Access Compliance Report

Public Rights-of-Way

(Curb Ramps)

Intersection ID: 28292	Main Street: ARVIND_OAKS_CT	Cross Street: KRISHNA_LN	Location: SE
ADA ID: 85A5B2FA5F8B	Ramp Type: PerpDiag	Initial Pass/Fail: Fail	Overall Compliance: No
Severity Score: 21.25			
Codes/Mitigation Info/Possible Solution		Field Measurements/Component Compliance

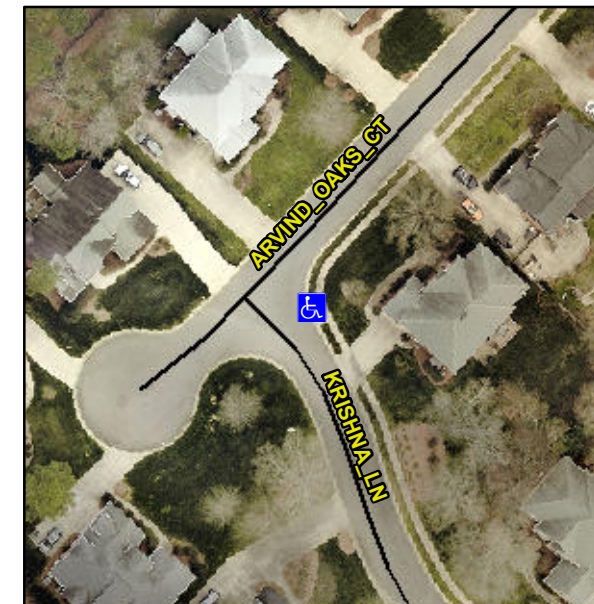
Not Found, R304.5.1, R304.2.2

Compliance	Description	Data	Compliance	Description	Data
N/A	Ramp Length (in)	47.0	No	Ramp Slope (%)	10.4
No	Ramp Width (in)	42.0	Yes	Ramp XSlope (%)	0.5
N/A	Flare Type LT	N/A	N/A	Flare Type RT	N/A
N/A	Flare Slope LT (%)	N/A	N/A	Flare Slope RT (%)	N/A
N/A	Flare Traversable LT?	N/A	N/A	Flare Traversable RT?	N/A
N/A	Landing Length (in)	N/A	N/A	DWS Provided?	N/A
N/A	Landing Width (in)	N/A	N/A	DWS Contrast?	N/A
N/A	Landing Slope (%)	N/A	N/A	DWS Length (in)	N/A
N/A	Landing X Slope (%)	N/A	N/A	DWS Full Width?	N/A
N/A	Landing Curb? (Y/N)	N/A	N/A	DWS Offset (in)	N/A
N/A	Shared Landing?	N/A			
N/A	Gutter Ponding?	N/A	N/A	Gutter Slope (%)	N/A
N/A	Gutter Lip Ht (in)	N/A	N/A	Gutter X Slope (%)	N/A
N/A	Painted X Walk1?	No	N/A	Painted X Walk2?	No
	X Walk 1 Direction	To NW		X Walk 2 Direction	To SW
N/A	X Walk 1 Width (in)	N/A	N/A	X Walk 2 Width (in)	N/A
	X Walk 1 Slope (%)	1.8		X Walk 2 Slope (%)	3.4
	X Walk 1 X Slope (%)	4.2		X Walk 2 X Slope (%)	2.1

Remove & Replace Curb Ramp With Two New Directional Ramps or Equivalent.
